TRANSPORT ASSESSMENT

PROPOSED WAREHOUSE DEVELOPMENT

LOT 47 YARRABILBA MIBA, YARRABILBA

(Response to Information Request dated 9 March 2026)

FIGURE 5.1 – PROPOSED LAYOUT AND DIMENSIONS OF PROPOSED VEHICLE CROSSOVER (OVERVIEW)

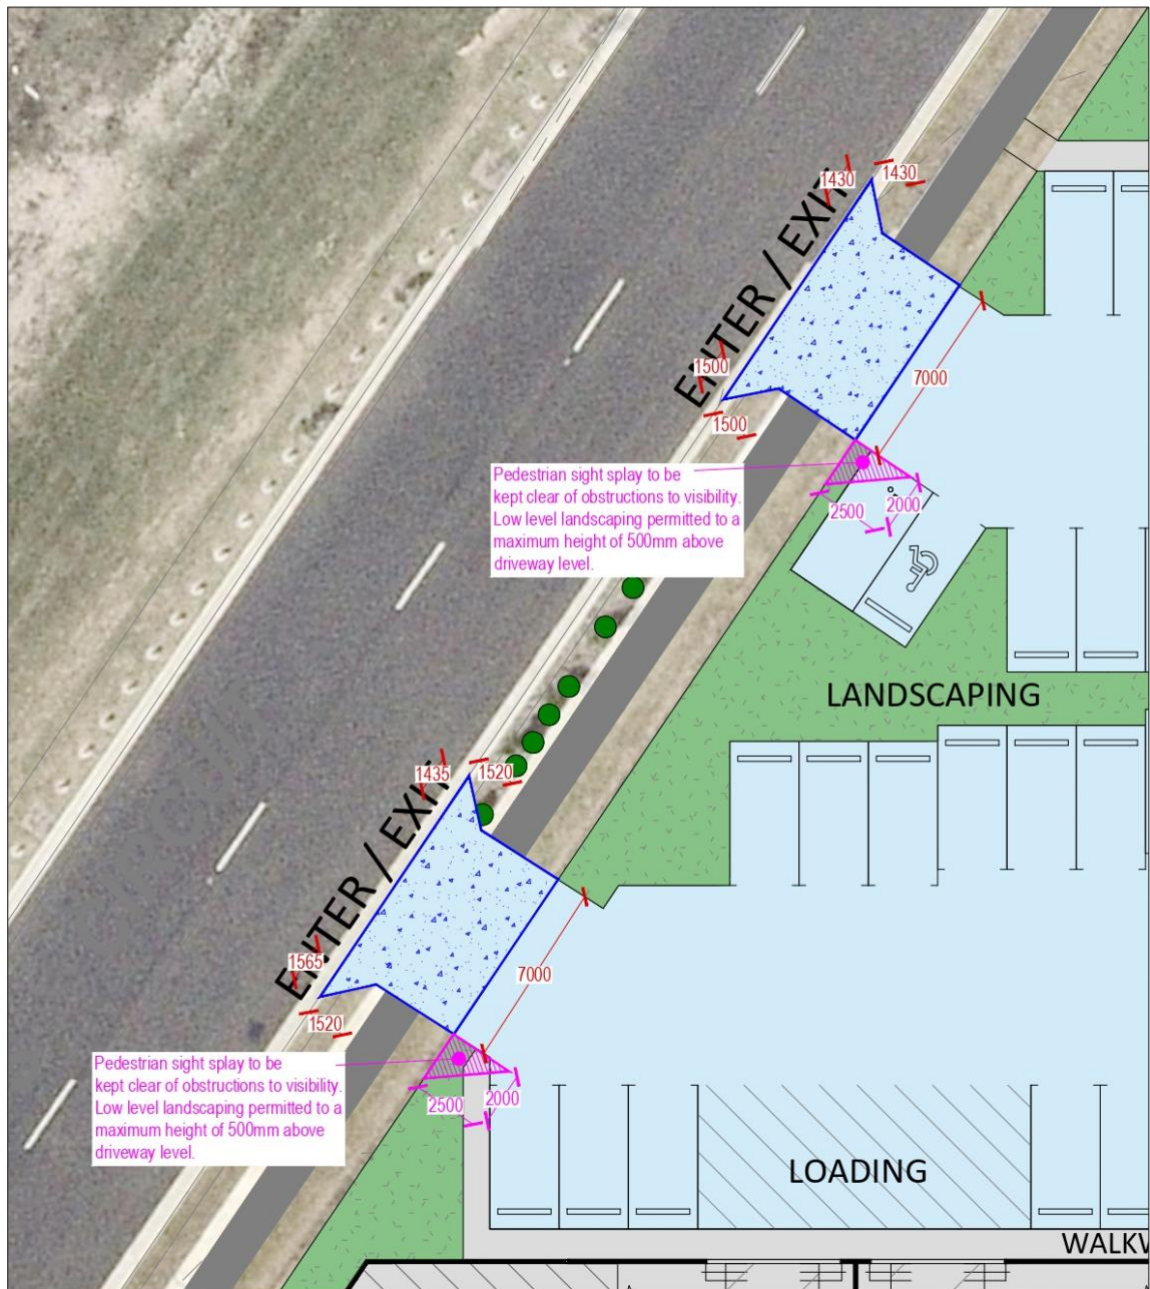
- Provide further HRV turning templates to demonstrate HRVs can enter proposed HRV bays which are shown inside the buildings (T1, T4 & T5 are of most concern). Turning templates have not been provided to show that HRVs can enter/exit the building to nominated HRV areas.
- Include queuing assessment including distance to first carpark. The design has multiple carparks within this minimum queuing area at driveways.
- Ensure the carpark layout achieves a minimum 5.8m aisle at the driveway entry. Aisle width is generally 6.6m (min), which complies with AS2890.1 table 1.1 & Figure 2.2, however it is noted that the carparks adjacent to driveways do not achieve a minimum 5.8m aisle (including the nominated PWD)

Given the proposed use, car parking will have a low turnover and the frontage road has a local / access function. The proposed parking located close to each entry will be used infrequently and will not have a significant impact on traffic entering the site. As shown below, the southern entry driveway provides queuing for one vehicle up to the first parking space, on the entry side. Drivers exiting from car parks positioned on the exit side of a driveway typically give way to entering vehicles.

It is noted that the proposal will only generate in the order of 16 vehicle movements per hour during peak periods, which equates to 5 – 6 entry movements per hour at each driveway (ie 1 entry every 10 minutes or so).
